PIC16C65A Rev. A Silicon Errata Sheet

The PIC16C65A (Rev. A) parts you have received conform functionally to the Device Data Sheet (DS30234D), except for the anomalies described below.

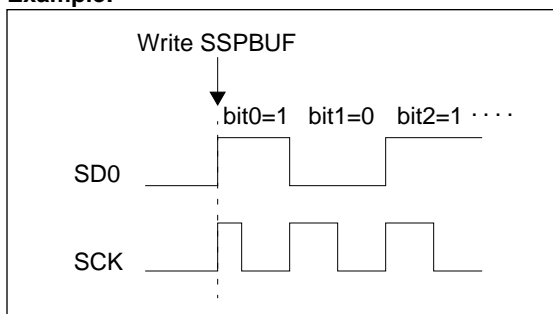
When the SPI is using Timer2/2 as the clock source, a shorter-than-expected SCK pulse may occur on the first bit of the transmitted/received data.

To avoid producing the short pulse, turn off Timer2 and clear the TMR2 register, load the SSPBUF with the data to transmit, and then turn Timer2 back on.

FIGURE 1: WRITES TO TIMER1 (EXTERNAL CLOCK / OSCILLATOR MODE)

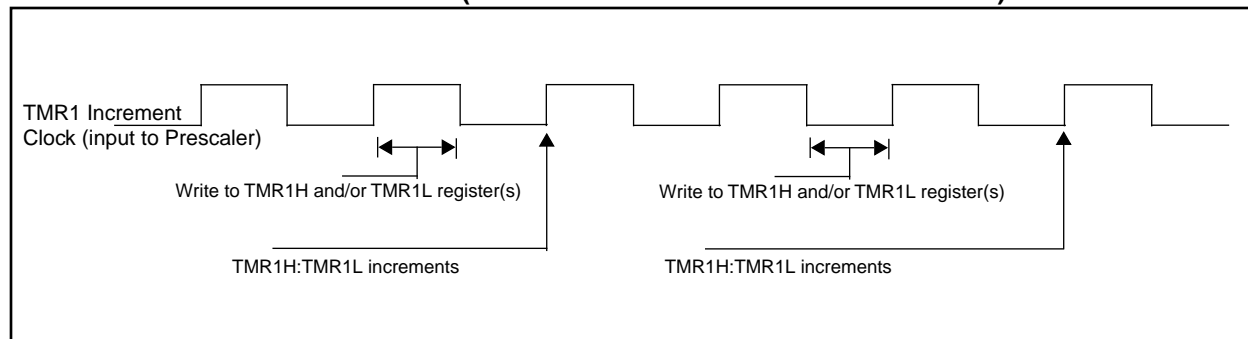
- a) The operation of Timer1 needs some clarification when the timer registers are written when the TMR1ON bit is set.
- The internal clock signal that is the input to the TMR1 prescaler affects the incrementing of Timer1 (TMR1H:TMR1L registers and the Timer1 prescaler). When the Timer1 registers are NOT written, the Timer1 will increment on the rising edge of the TMR1 increment clock.

When the TMR1H and/or TMR1L registers are written while this clock is high, TMR1 will increment on the next rising edge of this clock.

When the TMR1H and/or TMR1L registers are written while this clock is low, TMR1 will not increment on the next rising edge of this clock, but must first have a falling clock and then the rising clock for TMR1 to increment.

Figure 1 shows the two cases of writes to the TMR1H and/or TMR1L registers. Due to the V_{IH} and V_{IL} thresholds on the oscillator/clock pins, external

Timer1 oscillator components, and external clock frequency, the Timer1 increment clock may not be of a 50% duty cycle.

The TMR1 increment clock is out of phase of the T1OSO/T1CKI pin by a small propagation delay.
